Los Alamos National Laboratory

Date: FEB 28 1995
Refer to: EM/ER:95-J045

**SUBJECT: MODIFICATION TO THE RESOURCE CONSERVATION
AND RECOVERY ACT FACILITY INVESTIGATION (RFI)
WORK PLAN FOR OPERABLE UNIT (OU) 1147**

Enc.: (1) Summary of Proposed Drilling at MDA C
(2) Drawing of Proposed Drilling at MDA C

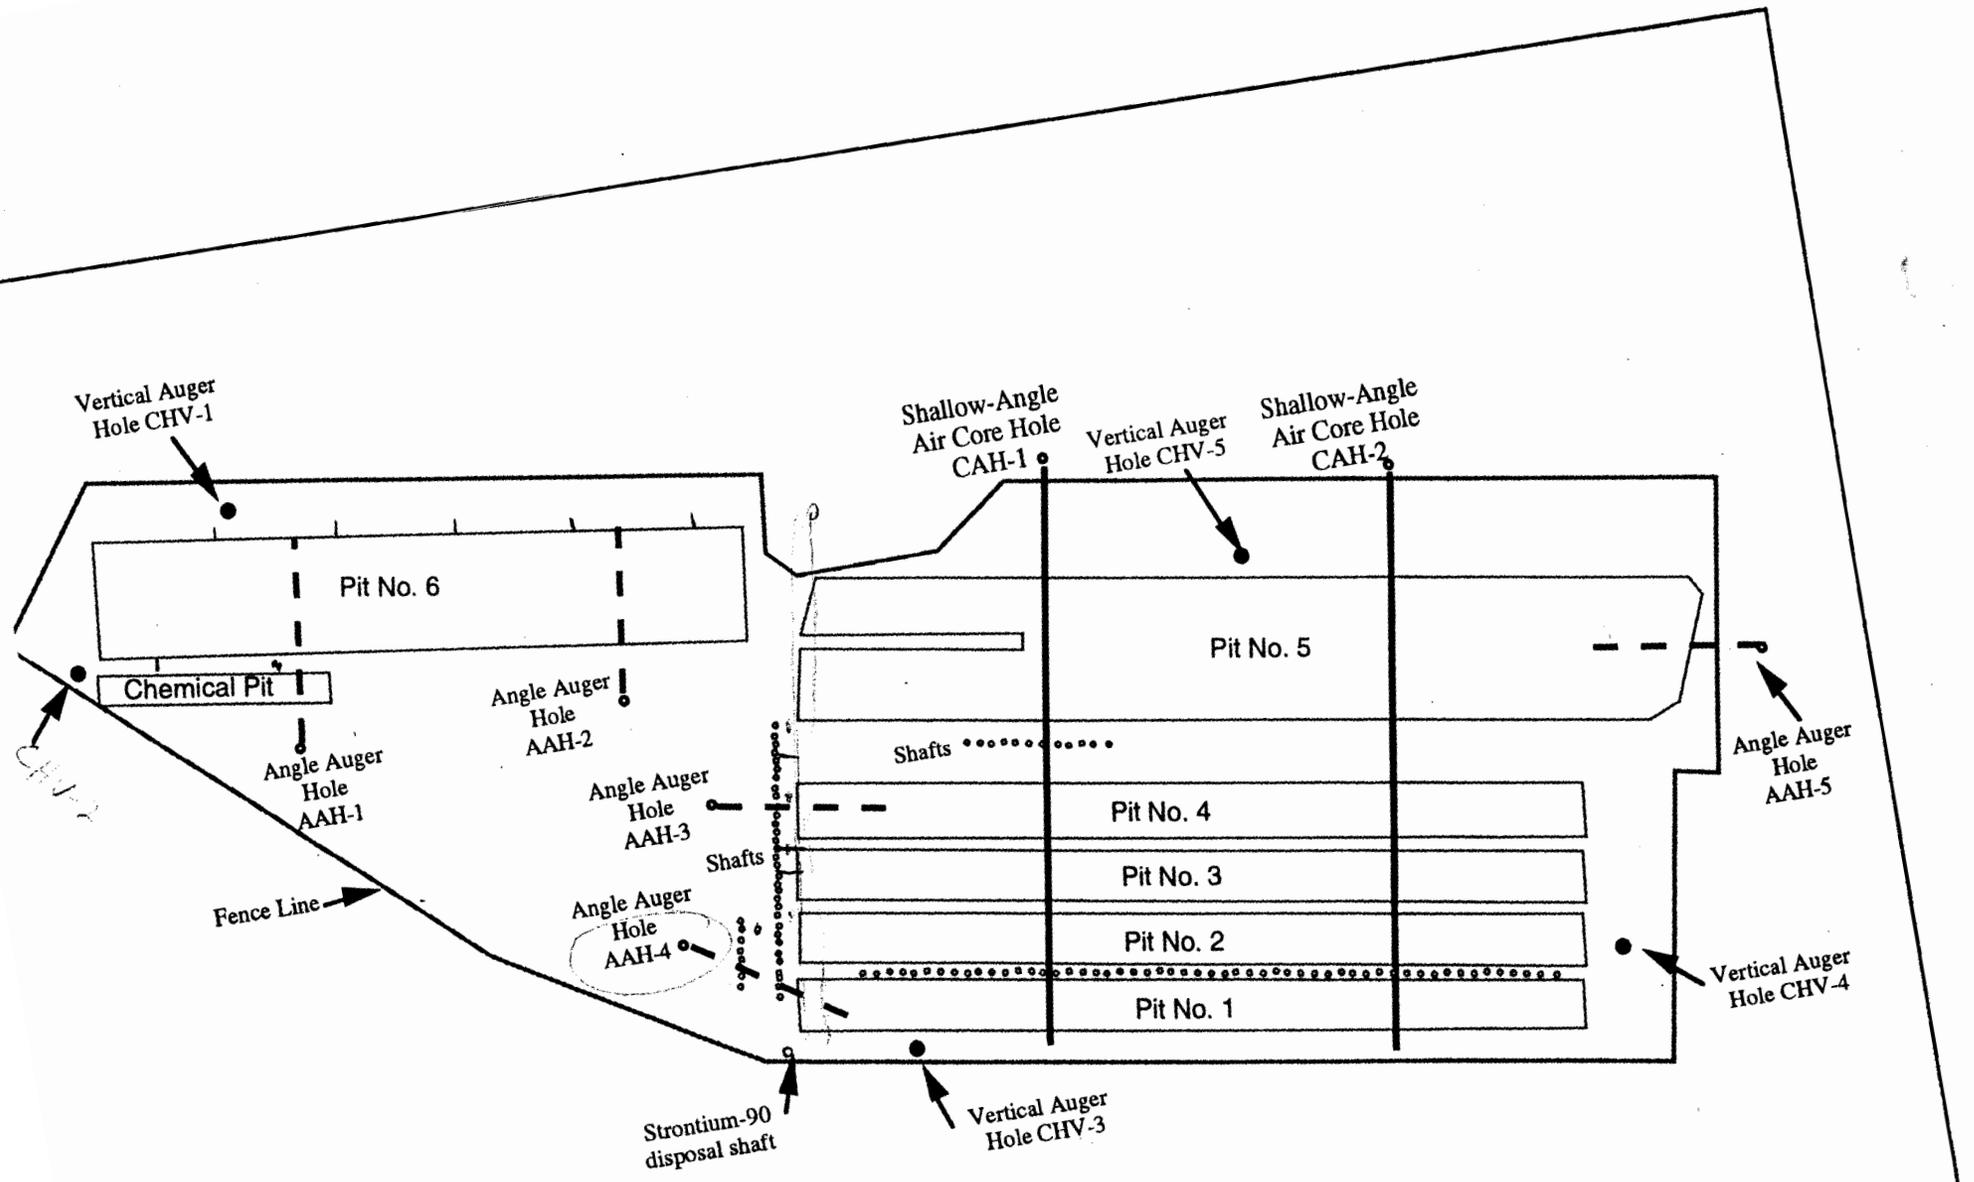
In particular, we recommend the following in place of the drilling plan given in the RFI Work Plan for OU 1147 (also indicated on the enclosed drawing):

1. Two shallow-angle air core holes east, traversing Pits No. 1 - 5 from north to south at approximately 1/3 and 2/3 of the distance across the pits from east to west. The length of these holes is about 500 feet. If the full length is not attainable with satisfactory core recovery, two additional angle auger holes will be added from north to south starting at the south fence line. Their length would be about 120 feet.

2. Two angle auger holes (about 120 ft long) directed under Chemical Pit and Pit No. 6, from south to north (designated AAH-1 and AAH-2, respectively).
3. One angle auger hole (about 120 ft long) at the west end of Pit No. 4 (AAH-3), west of the shafts from west to east. One angle auger hole (about 120 ft long) at the west end of Pit No. 1 (AAH-4), west of the shafts from west to east.
4. One angle auger hole (about 120 ft long) at the east end of Pit No. 5 from east to west (AAH-5).
5. All CVH vertical auger holes to be moved closer (within 25 feet) to waste units.
